# CITY OF ALBUQUERQUE

**Re: Project Name**  
**601 Mountain Road NW**  
**Traffic Circulation Layout**  
Architect's Stamp 06-23-2020 (J14-D195)

Project: 6TH AND MOUNTAIN  
Drawn By: KMA  
Checked By: KMA  
Permit Set  
Date: 06/17/2020  
Drawing Title: ARCHITECTURAL  
SITE PLAN  
TRAFFIC  
CIRCULATION  
PLAN  
Project Number: 19012  
Sheet Number:

AS100

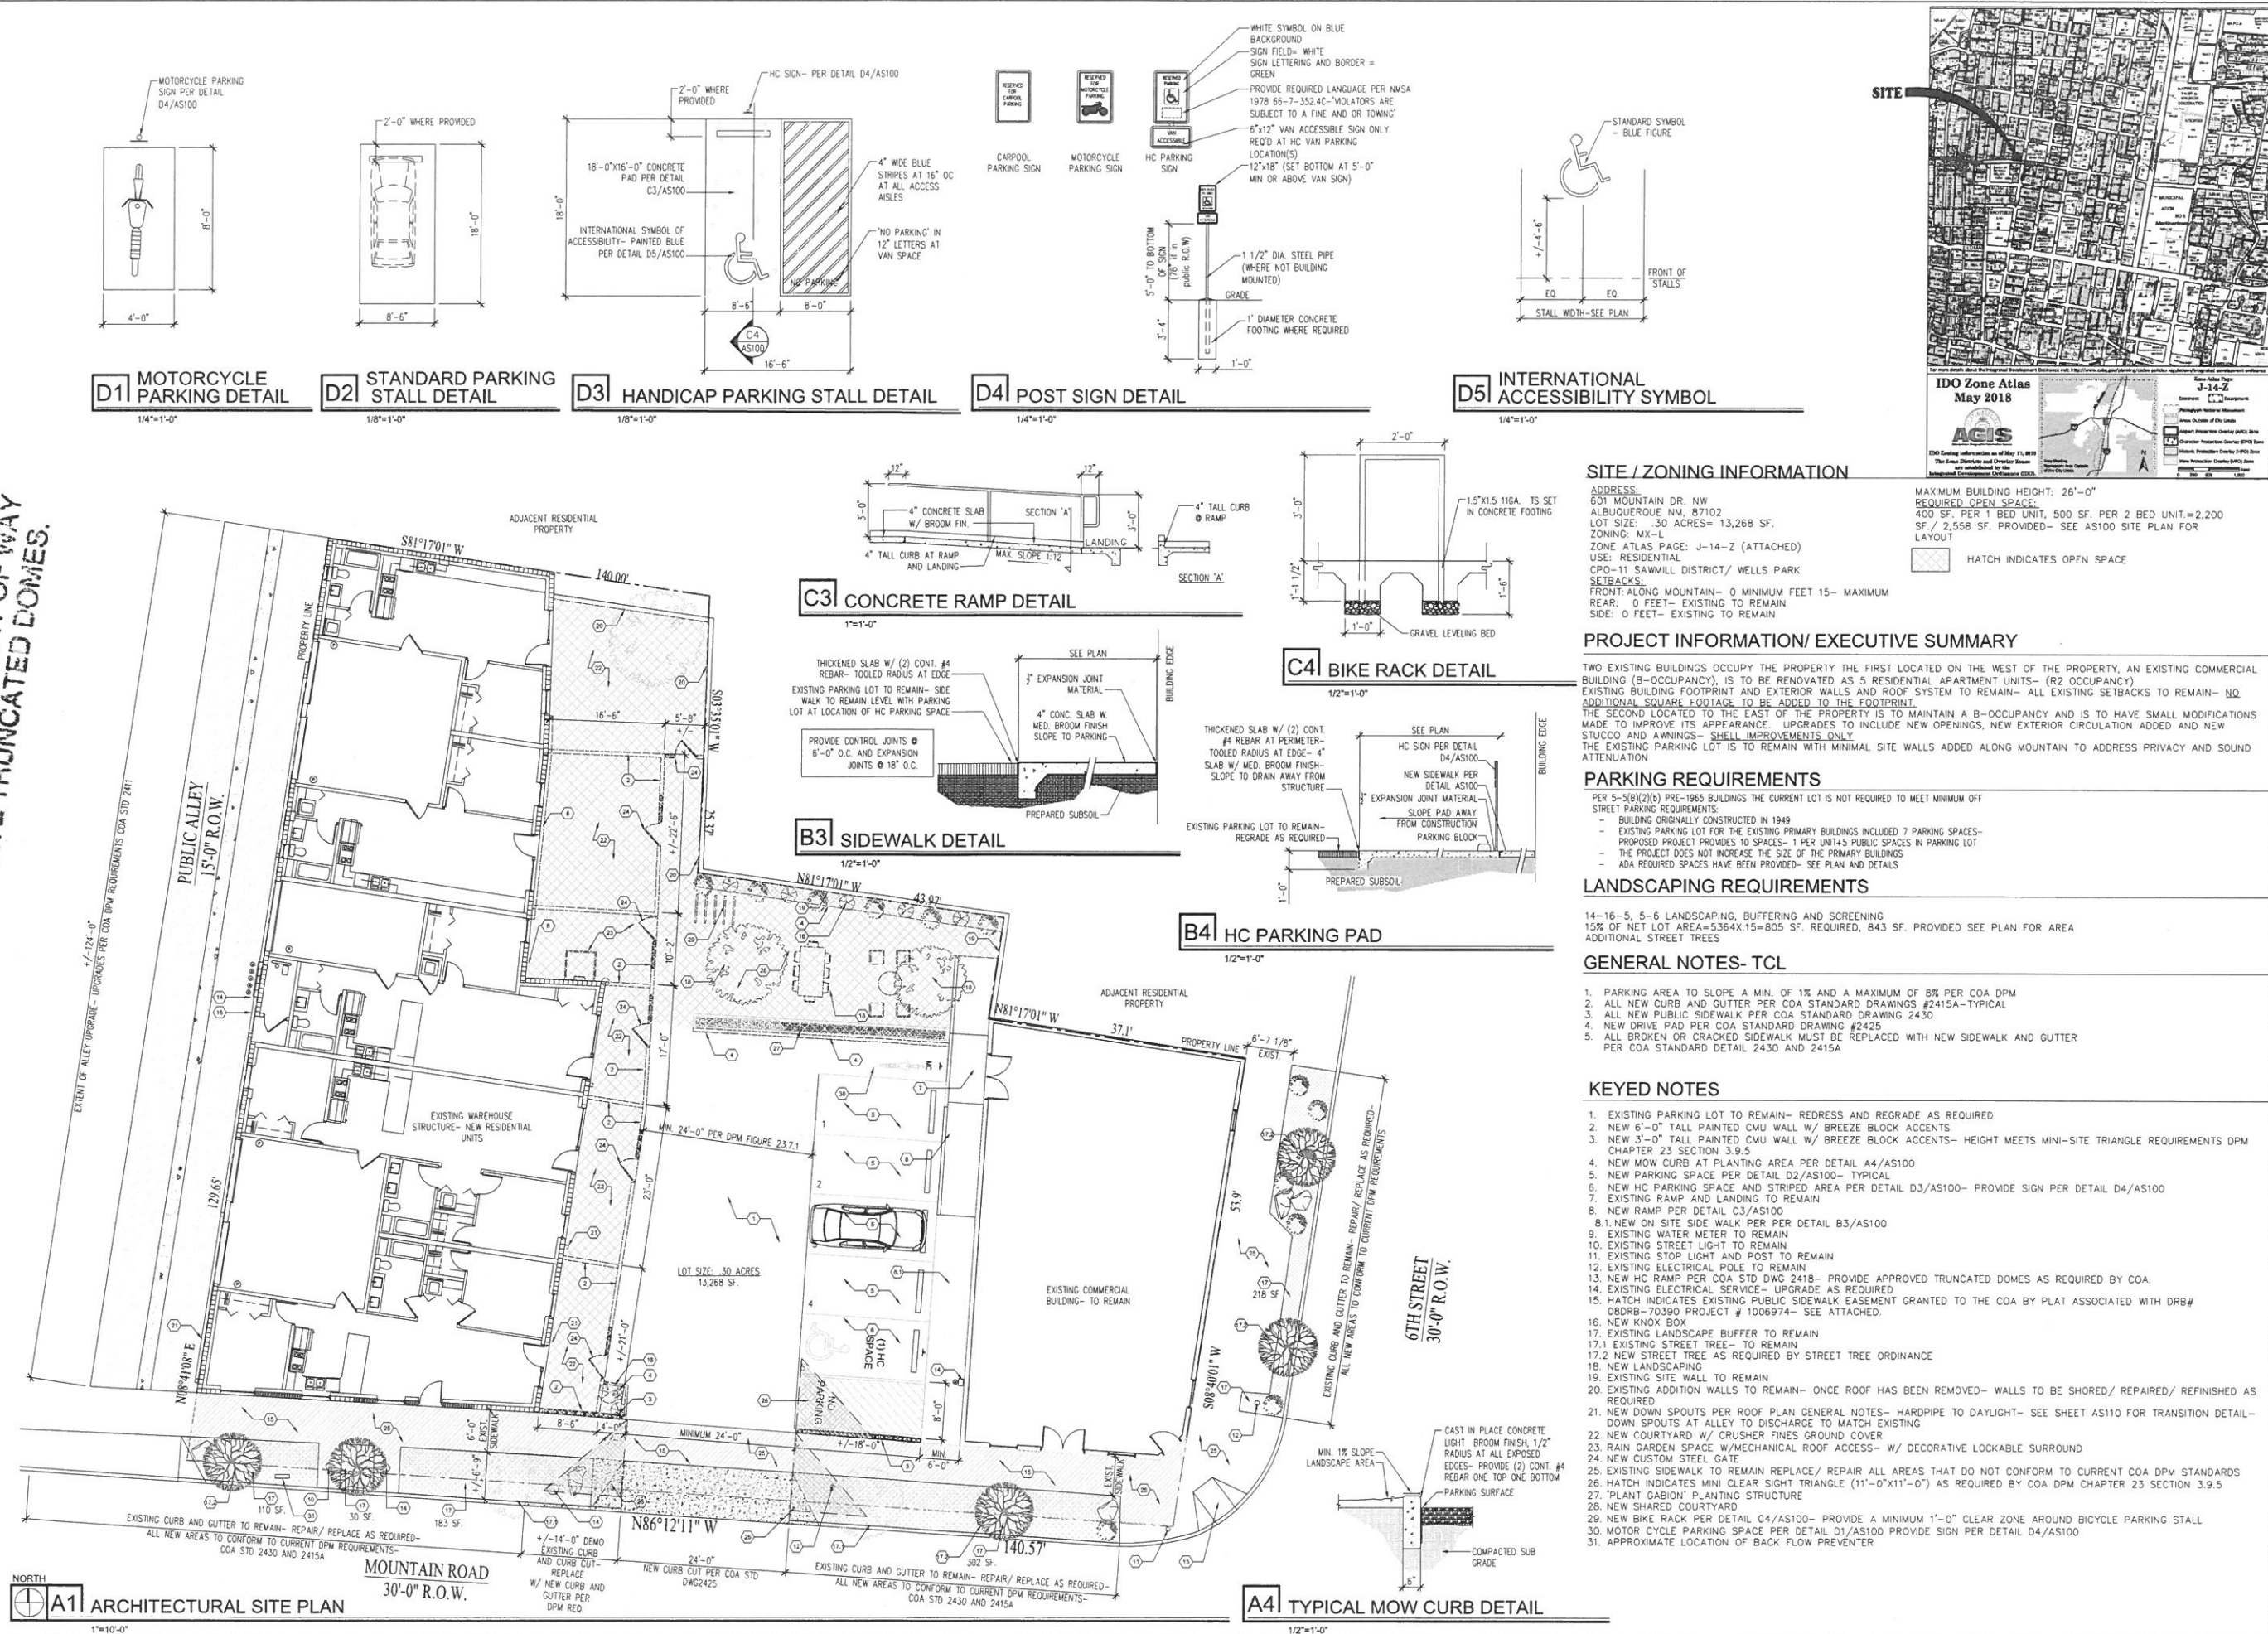
ALL WHEELCHAIR RAMPS LOCATED WITHIN THE PUBLIC RIGHT OF WAY MUST HAVE TRUNCATED DOMES.
